802.3dj D1.1

Comment Resolution

Electrical Topics

Adee Ran (Cisco), 802.3dj Electrical Lead Editor
<others>

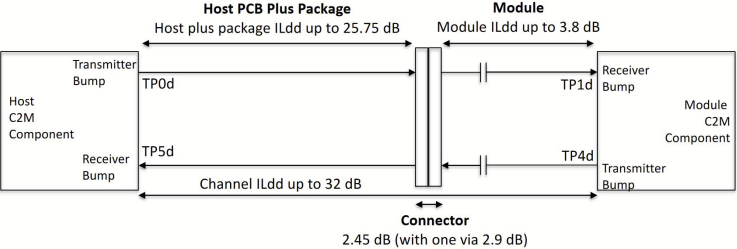
CI 176E SC 176E.2 P695 L40 # 115

Figure TBDs

These two comments effectively suggest values for the host channel insertion loss.

- Adopt 34 dB as the reference max ILdd between TP0d and TP1a.
- Adopt the COM channel model parameters of "option 2" on slide 16 of ran_3dj_01b_2407 . Use these parameters for the host PCB model for C2M in Table 176E-5. Delete the "Class A package model" row and set "Transmission line 1 length" in the "Class B package model" row to 45 mm (one value).

- In Table 176E-9, change TBDs in "Test channel insertion loss at 53.125 GHz" row (module test) to: Low loss: min=9 dB, max:10 dB (a mated test fixture), High loss: min=33.5 dB, max=34.5 dB (reference TP0d-TP1a loss +/- 0.5 dB)

- Use the table format suggested in slide in ran_3dj_03_2409 instead of having ILdd values in the figure. Fill in the following values:
 - For module ILdd: 3.8 dB, for host channel including connector: 28.2 dB (as in slide 7 of ghiasi_3dj_03_2409).

Creating C2M module specifications (cont)

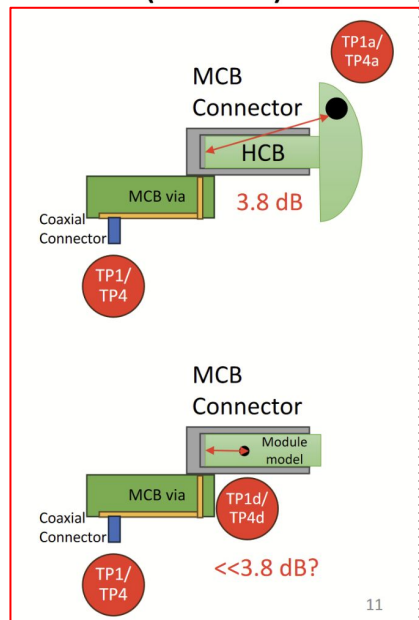
- Even if we had a reference model for the module... deriving input/output specifications is more complicated than the host case
- We need reference models of the TP1-TP1d and TP4d-TP4 channels
 - These are shorter than TP1-TP1a and TP4a-TP4 in a mated test fixture
 - We can't start with measured MTF S-parameters and add some mathematical model, as in the host case...
- Contributions in this area are encouraged
 - Mathematical expressions
 - Explicit S-parameters
 - Combinations
 - Other ideas

With an allocation of 3.8 dB to the HCB, The insertion loss between TP1d and TP1a is likely about 3 dB (it may be lower if the DSP in the module is packaged).
